TECHNICAL INFORMATION

No: 84/02/03/NAS	
Ref:	
Issue: 1	
Date: 04/11/03

Washer Jets Weep

AFFECTED VEHICLE RANGE:
Discovery Series II (LT) Up to 3A777039

Figure 1

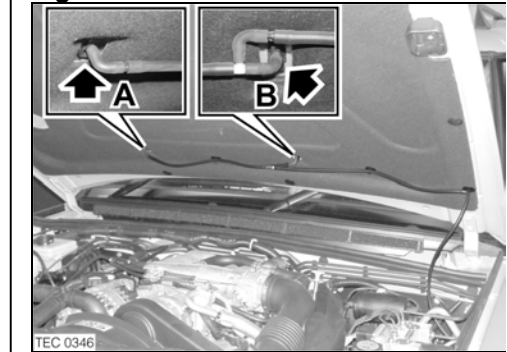
SITUATION:
FRONT WASHER JETS LEAK
 The owner may complain that the front washer jets weep and leave fluid on the hood surface. This symptom may be caused by the check valve location being too far removed from the jet. Washer fluid trapped between the check valve and the jet can expand due to engine compartment temperatures and weep onto the hood.

RESOLUTION:
INSTALL NEW TUBING WITH CHECK VALVE
 Installation of a new tubing assembly with revised check valve location will resolve the weeping problem.

1. Disconnect the washer hose assembly from the washer jets. (A and B in Figure 1)
2. Release the 90° hose connector from the hood. (C in Figure 2)
3. Disconnect the supply hose from the connector (B in Figure 2).
4. Release the washer hose assembly from the clips on the hood (A in Figure 2)
5. Remove the old washer hose assembly.
6. Connect the new washer hose assembly to the washer jets.
7. Connect the supply hose to the new 90° connector.
8. Install the 90° connector onto the hood.
9. Install the washer hose assembly into the clips on the hood.
10. Operate the windscreen washers to verify correct operation.
11. Verify there are no leaks in the washer system.
12. Top up the windscreen washer reservoir.
